## Application for Works Approval

**Works Approval Number** W3153/2025/1

**Applicant** Western Queen Pty Ltd

**Premises** Western Queen Gold Project  
Mining Tenements M59/208 and M59/45  
As defined by the premises map attached to the issued works approval

Figure 1: Conceptual water management schematic

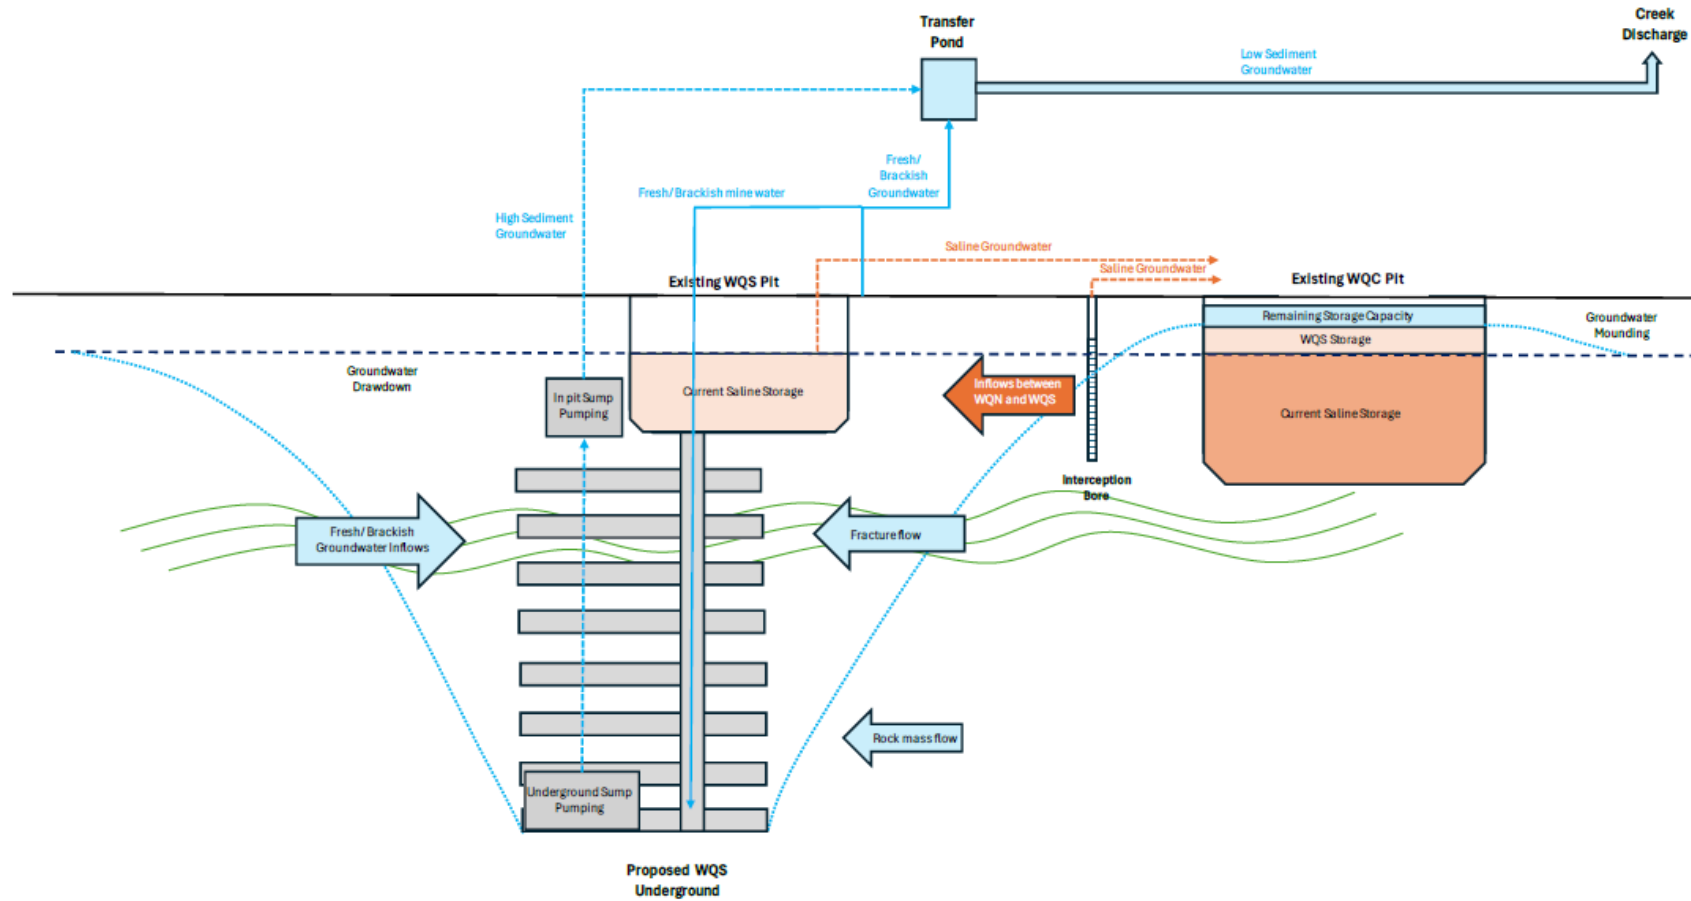
Condition	Summary of applicant's comment	Department's response
Decision Report – Figure 1	Figure 1 in the Decision Report has been replaced with updated figure from the 2026 surface water report, provided in Attachment 12.	Figure 1 has been replaced with the figure provided in Attachment 12.
Decision Report – Figure 2	Figure 2 of the predicted wetting fronts of creek line, has been replaced with updated figure from the 2026 groundwater report, provided in Attachment 10.	Figure 2 has been replaced with the figure provided in Attachment 10.
Surface Water Assessment Report	An updated Surface Water Assessment Report (AECOM 2026a) has been submitted, as provided in Attachment 13.	<p>Due to the report being updated, some amounts regarding discharge rates in the decision report have changed. All changes have been reflected into the report and do not impact on the risk assessment.</p> <p>The reference has been updated.</p>
